Highway Officer: Robert Smith
Our ref: AVBC/2026/016355
Your ref: AVA/2026/0124
Date: 18 March 2026

TOWN AND COUNTRY PLANNING ACT 1990
(DEVELOPMENT MANAGEMENT PROCEDURE) (ENGLAND) ORDER 2015
ARTICLE 18 CONSULTATION WITH HIGHWAY AUTHORITY

PROPOSAL: Outline application for 4 dwellings

LOCATION: Windmill View Nurseries Spanker Lane Nether Heage Belper Derbyshire DE56 2AT

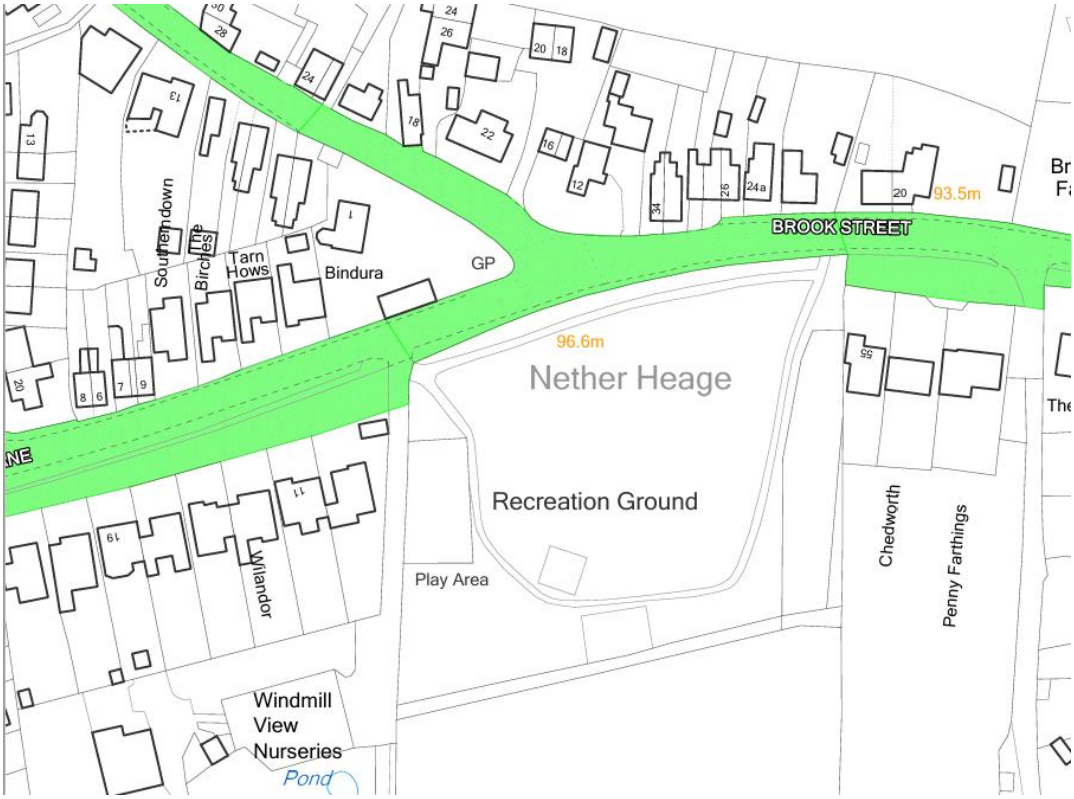
For the avoidance of doubt, relevant to the above requirements given that works are required within the highway, the extent of the highway in the vicinity of the site access is shown shaded green on the following copy extract from the highway authority's records.

- The shared driveway shall have a minimum width of 4.8m for the first 8m measured from the back of the southern footway on Spanker Lane. Where it falls within the highway the hard surfaced crossing and driveway should be constructed in accordance with the highway authority's specification.

- The shared driveway shall have a bound surface over a length of at least 5m measured into the site from the highway boundary.

- Provision to prevent the unregulated discharge of surface water to the public highway.

- Feature(s) to safeguard pedestrians at the site access adjacent Nether Heage Recreation Ground, i.e. physical barrier, safe standing space for pedestrians to wait adjacent to the driveway, surface markings/lettering, and/or signage.
